Treatment of Reactor Systems within Draft Regulatory Guide 1.183 DG-1199

In this note, a review of concerns relevant to Draft Regulatory Guide 1.183 rev.1 (DG-1199) is presented. These comments pertain to the treatment of the main steam line isolation valve (MSIV), emergency core cooling system (ECCS) and engineered safety features (ESF) during postulated accident scenarios contained within the regulatory guide. These comments are particularly salient to the mitigation and decontamination of the full core source created during a loss of coolant accident (LOCA) for boiling water reactors (BWRs).

Figure 2: Decontamination factor for a well-mixed pipe with a constant flow rate and aerosol undergoing gravitational settling. (Gelbard, 2017)

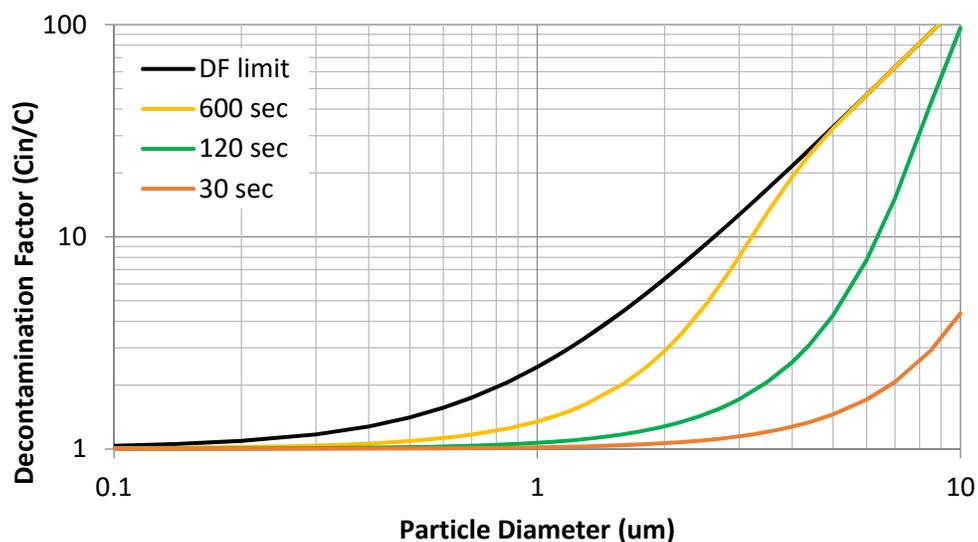
Decontamination factors for aerosol deposition in a main steam line under conditions similar to those expected in an accident scenario were calculated using the same methodology found within the severe accident analysis code MELCOR. Two separate cases were examined and are included within Gelbard (2017). The first is a single volume which assumes a well-mixed pipe. This is shown in Figure 2. The second is a plug flow, which provides the limit as the number of control volumes in the main steam lines. See Figure 3. Both calculations were for 5.0 m long main steam line sections. (Gelbard, 2017)

It can be seen that both of these decontamination factors are highly dependent on the size of the aerosol particles in question. Recommended distributions from the OECD/NEA “State-Of-The-Art Report on Nuclear Aerosols” and the distribution used by Metcalf and Perez (2010) are presented in Figure 4. (Allelein et al, 2009) (Kissane, 2008)

- It is recommended that the aerosol size distributions detailed by State-Of-The-Art-Report on Nuclear Aerosols be used for nuclear accident applications, since this report contains the most up-to-date information. Therefore, the lower decontamination factors in SAND2008-6601 and RG1.183 DG-1199, compared to Metcalf and Perez (2010), are a better estimate for the postulated LOCA and the conservative case.

Figure 4: PDF of initial aerosol concentration, showing two separate concentrations based on the State-of-the-Art Report on Nuclear Aerosols (Allelein et al, 2009), and one based on the AEB-98-03 distribution (Schaperow, 1998).

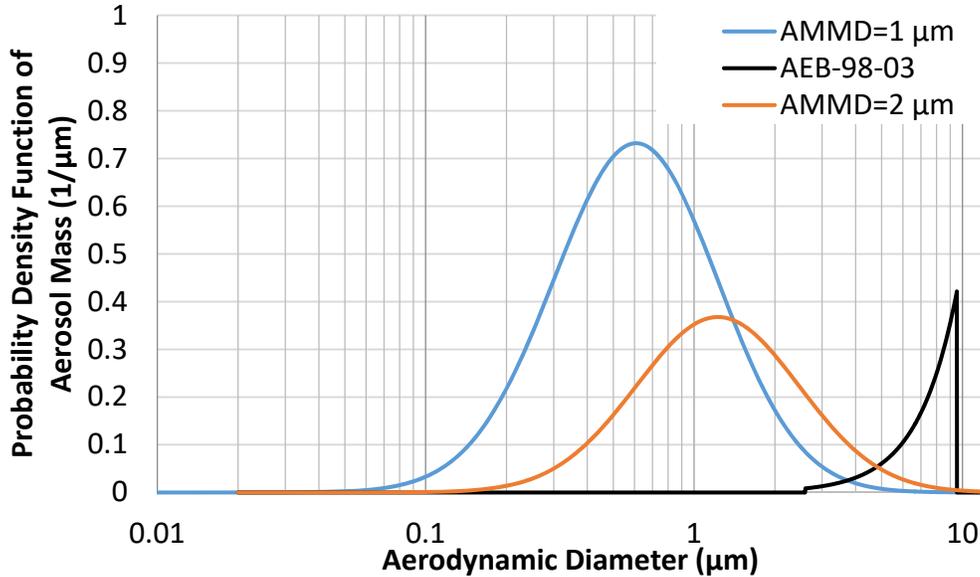
The “State-of-the-Art Report on Nuclear Aerosols”, recommends a lognormal distribution with a range of Aerosol Mass Median Diameter (AMMD) from 1.0 to 2.0 μm with a geometric standard deviation (GSD) of 2.0. (Allelein et al, 2009) Metcalf and Perez (2010) used the aerosol concentration presented in “Assessment of radiological consequences for the Perry pilot plant application using the revised (NUREG-1465) source term,” issued as technical report AEB-98-03. It is uniform between equivalent aerosol diameters between 1.5 and 5.5 μm ; the conversion of this to aerodynamic diameter is covered in Gelbard (2017).

When applying the decontamination factors calculated using the methodology contained within MELCOR, it is found that the overall decontamination factors for the 1 μm AMMD and the 2 μm AMMD distributions are significantly less than decontamination factor claimed in Metcalf and Perez (2010). However, if the aerosol size distribution from AEB-98-03 (Schaperow et al, 1998), which was used by Metcalf and Perez (2010), is applied, then a higher decontamination factor is calculated.
